December 5, 2024

BYTEK VW Expansion Project
1325 St. Laurent Blvd.
Ottawa, Ontario
Our Ref: 2301

Addendum N° 5

OTTAWA ONTARIO
DRAWING
ELEVATIONS

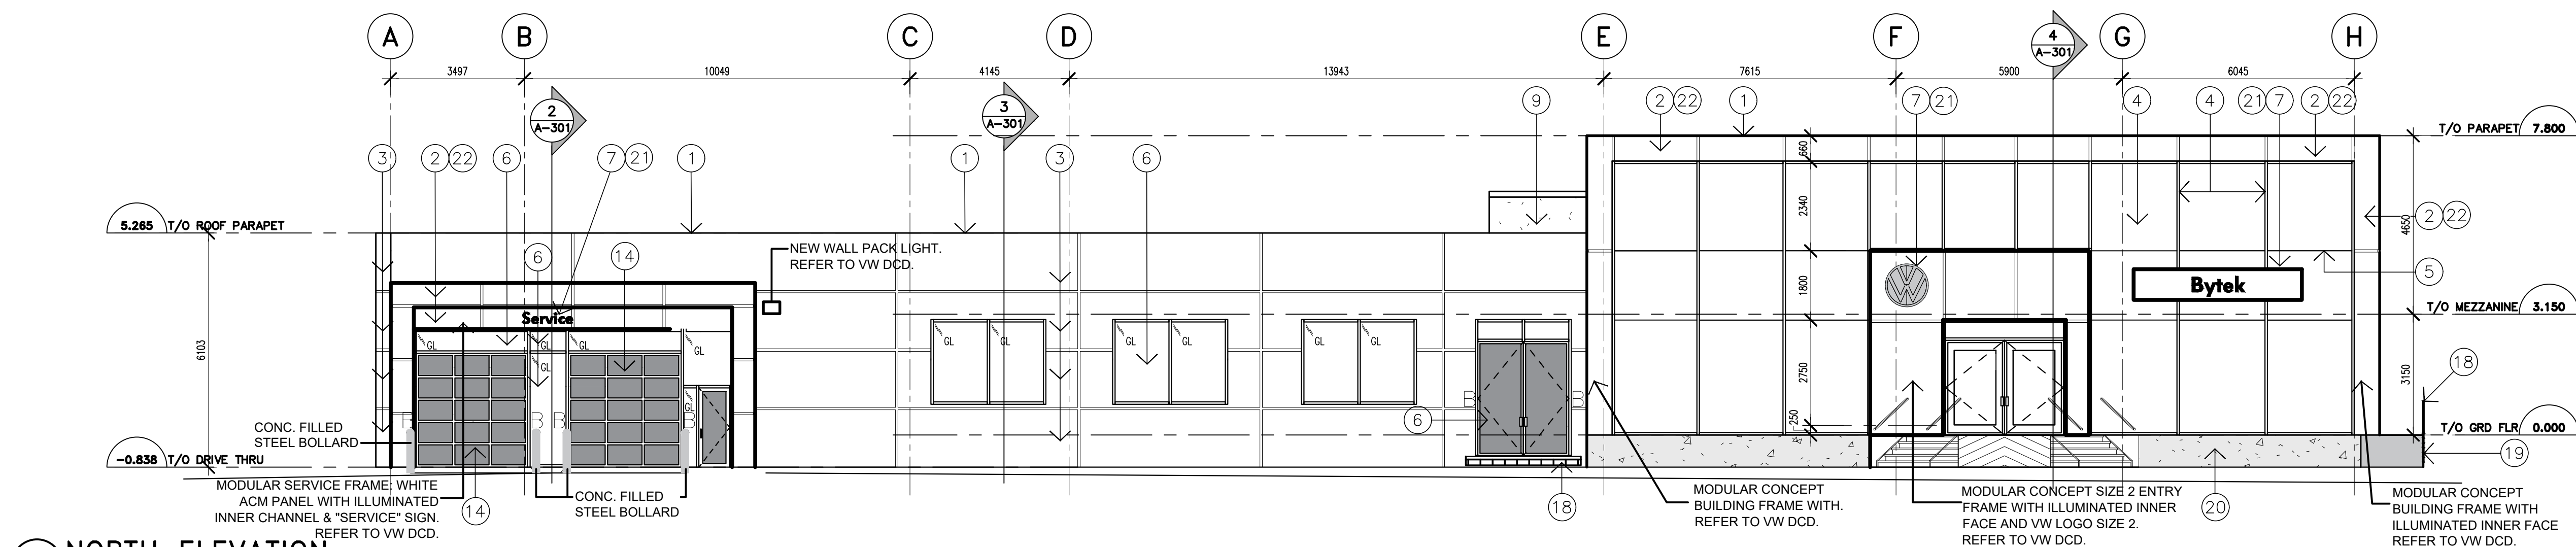
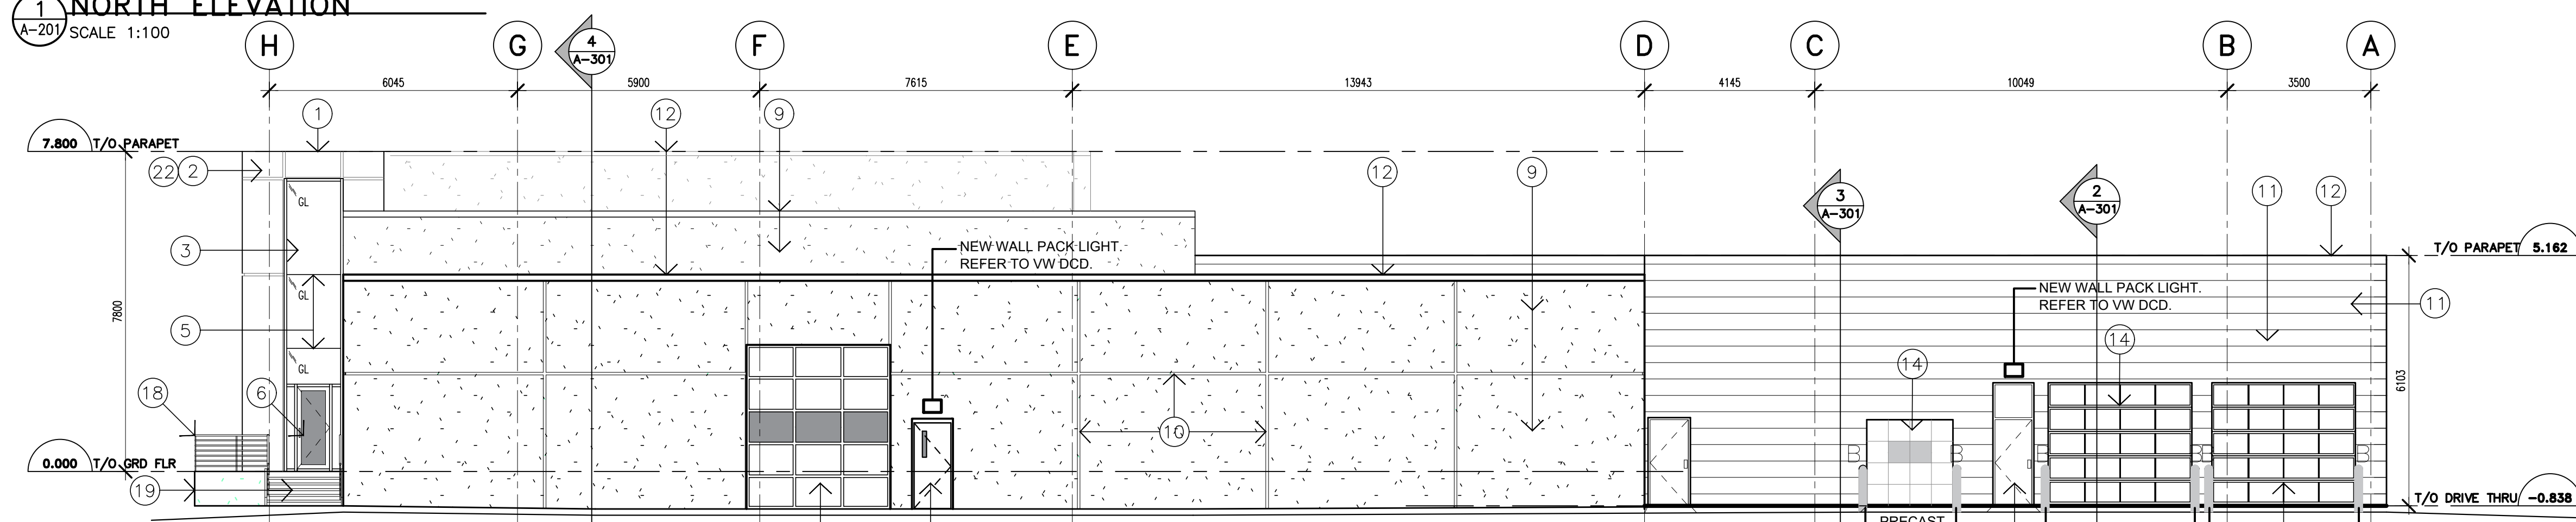
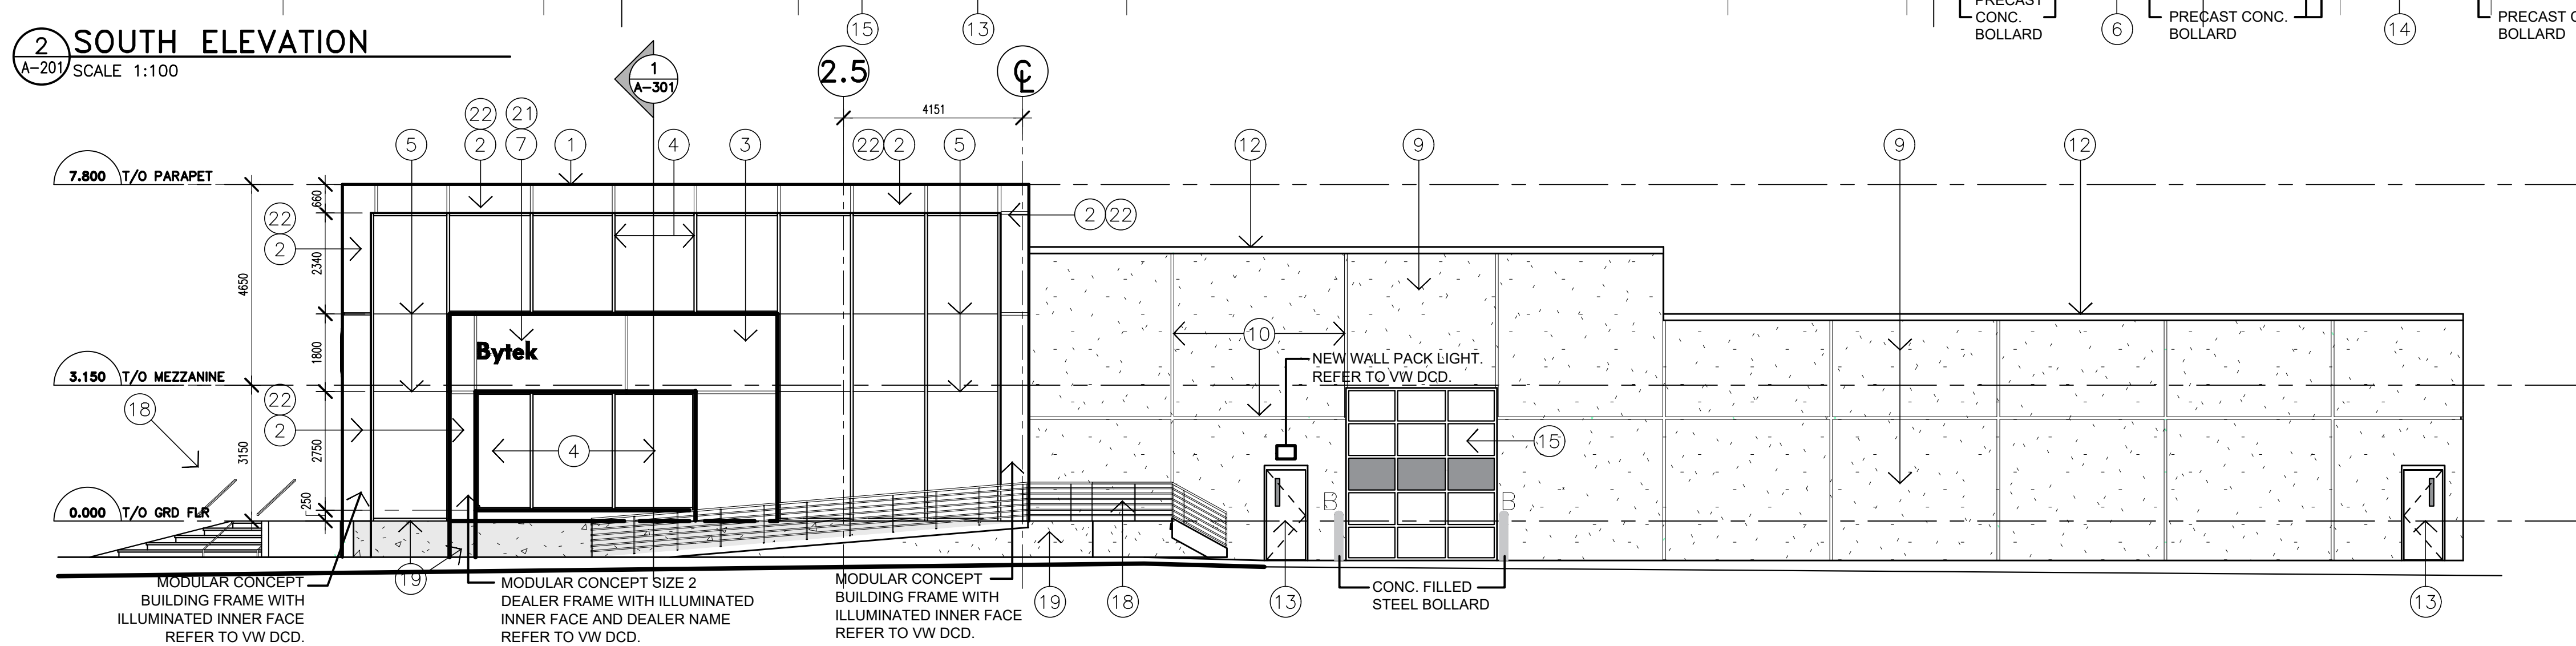
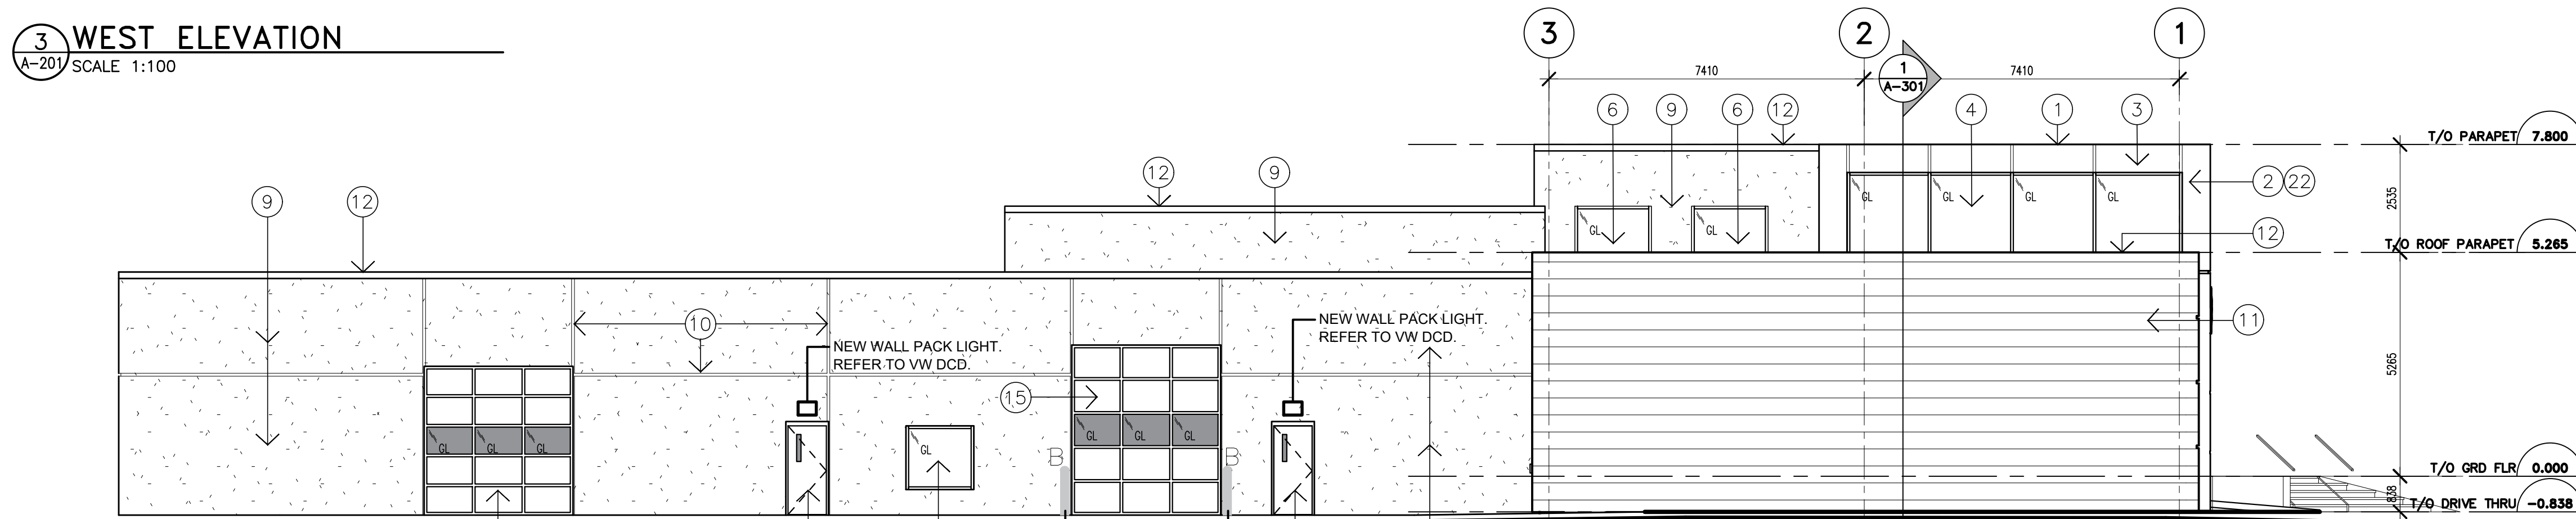
- 1.2 Reference drawings A-201, Elevations, Revised
 - 1.2.1 Signage and lighting.
 - 1.2.2 Elevations revised to reflect size of floor plan.
- 1.3 Reference drawings A-001, Site Plan, Revised

1.16 Reference drawings A-201, Elevations, clarification,

1.16.1 No new masonry on exterior elevations.

MEZZANINE & BASEMENT
REFLECTED CEILING PLAN

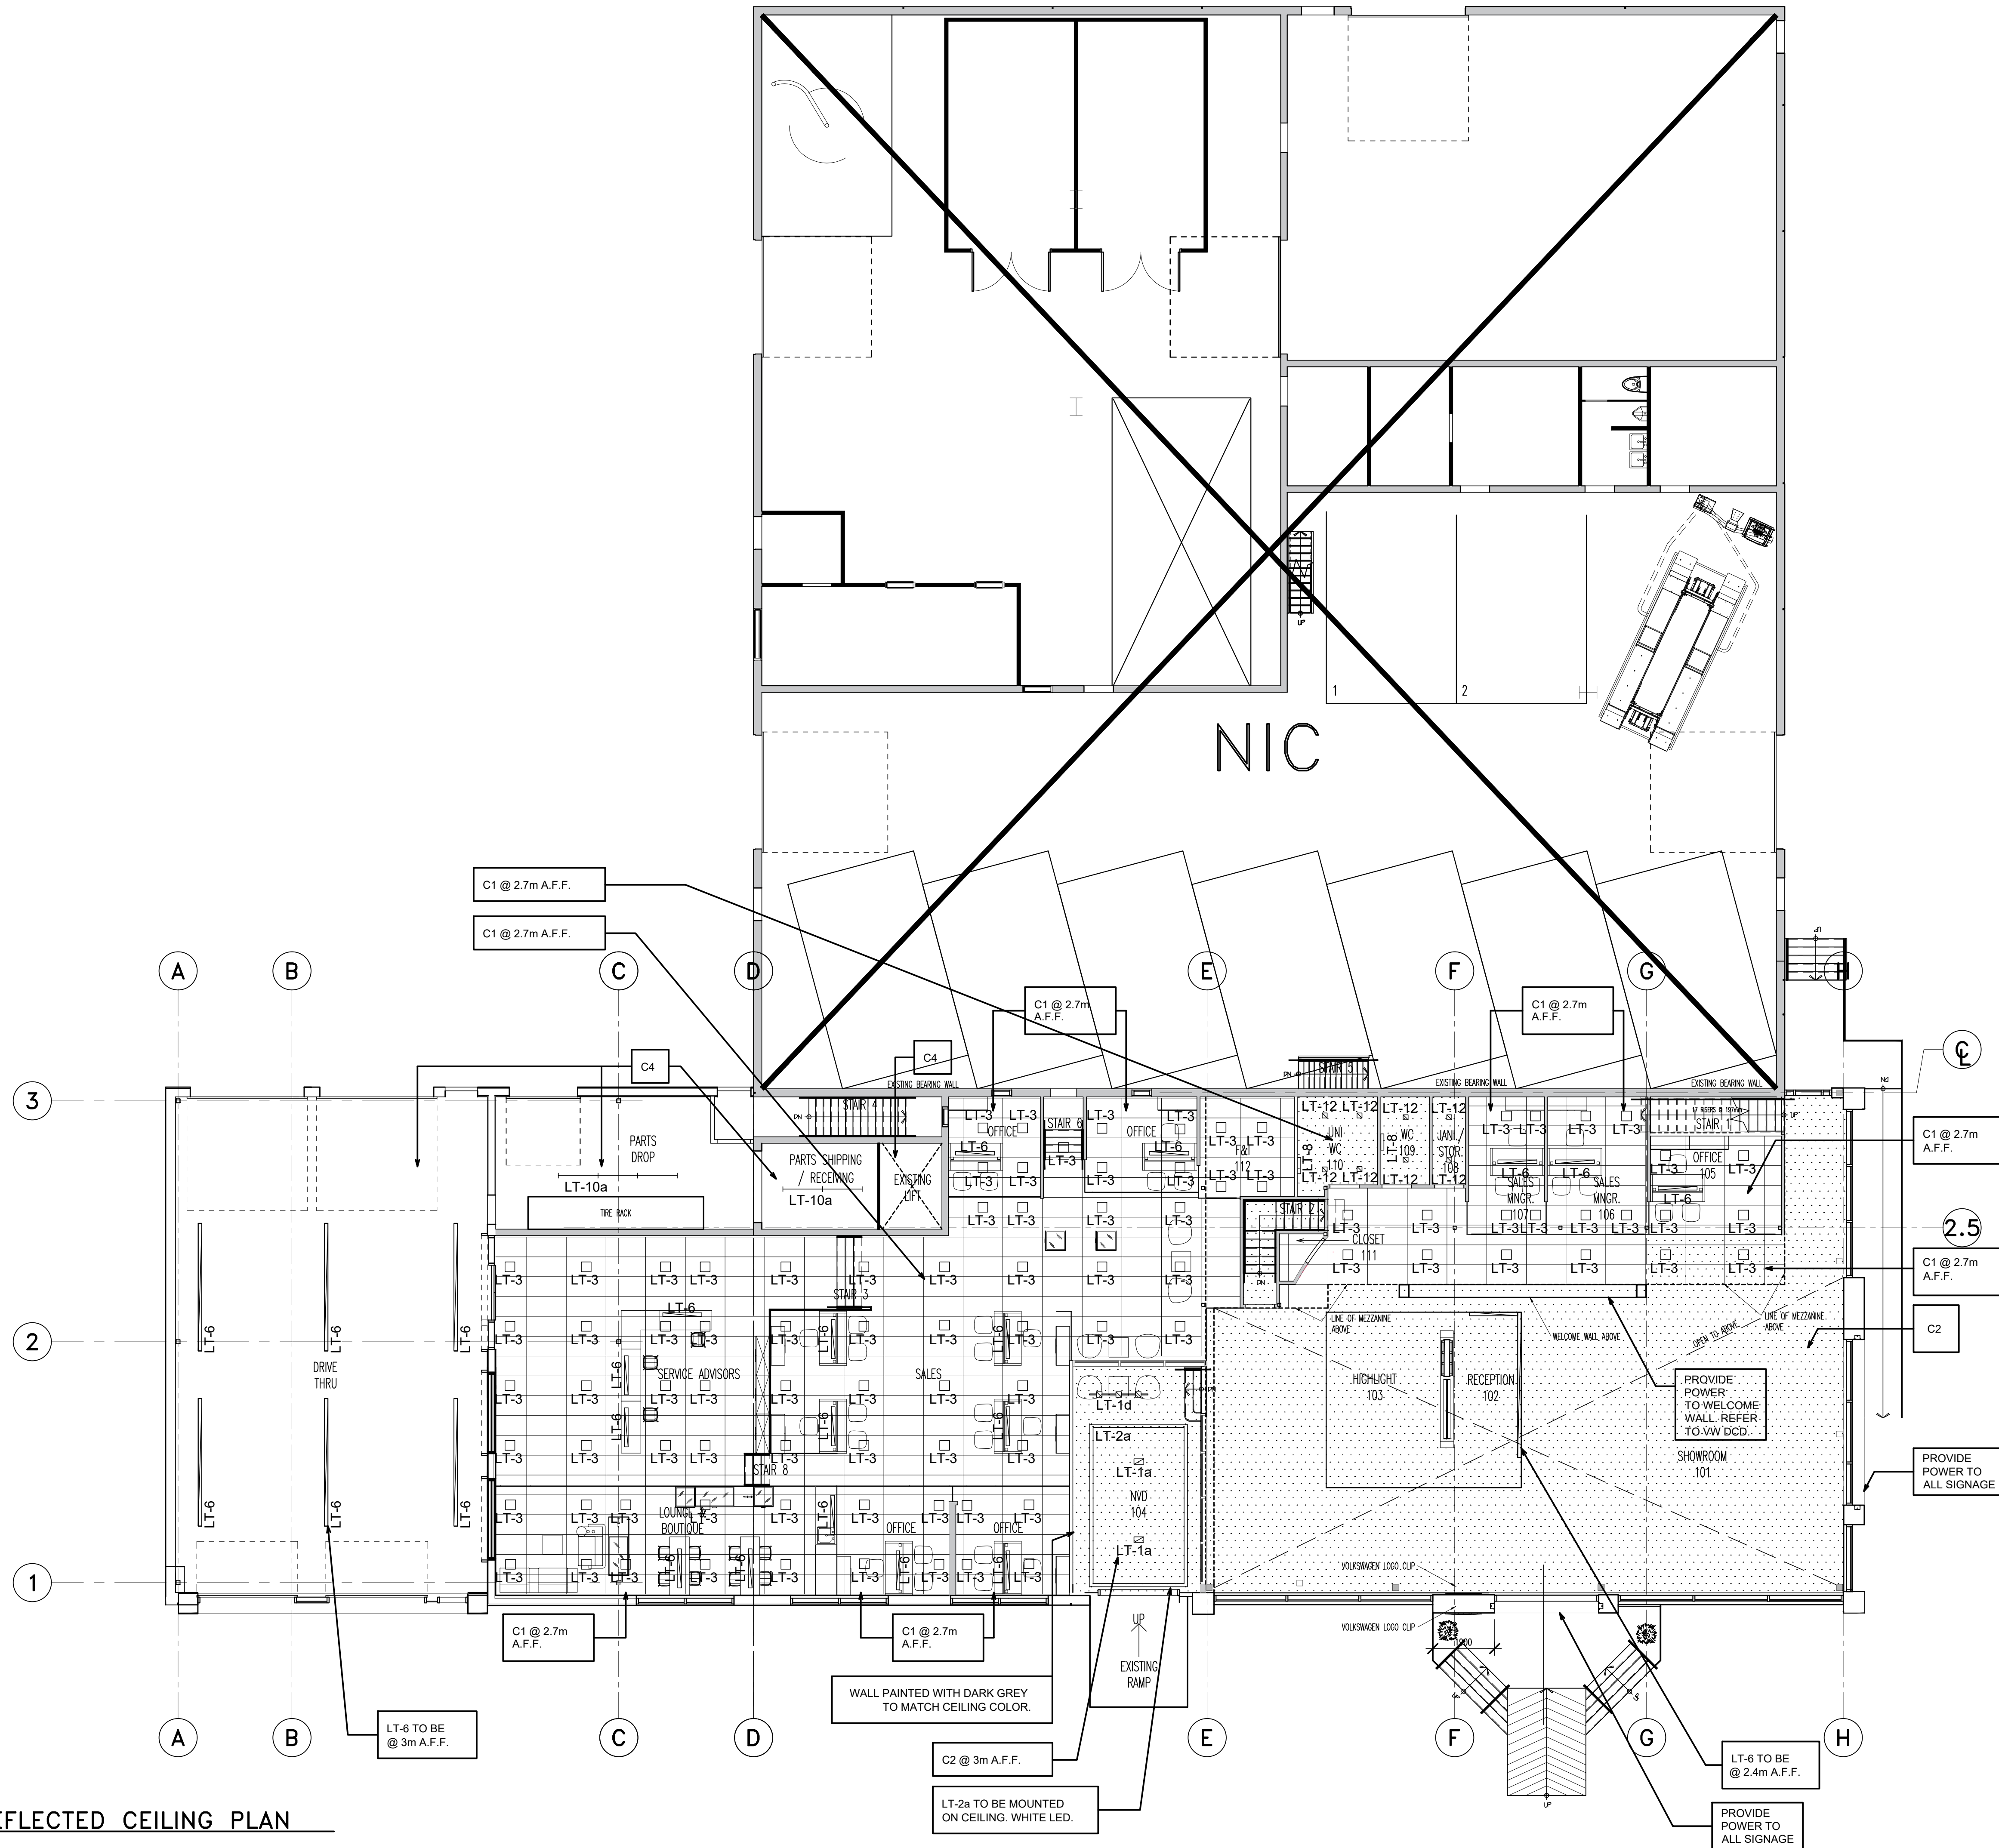
- 1.1 Reference drawings A-503, Mezzanine and Basement Reflected Ceiling Plans and A-504, Ground Floor Reflected Ceiling Plan, Revised
 - 1.1.1 Signage and lighting.
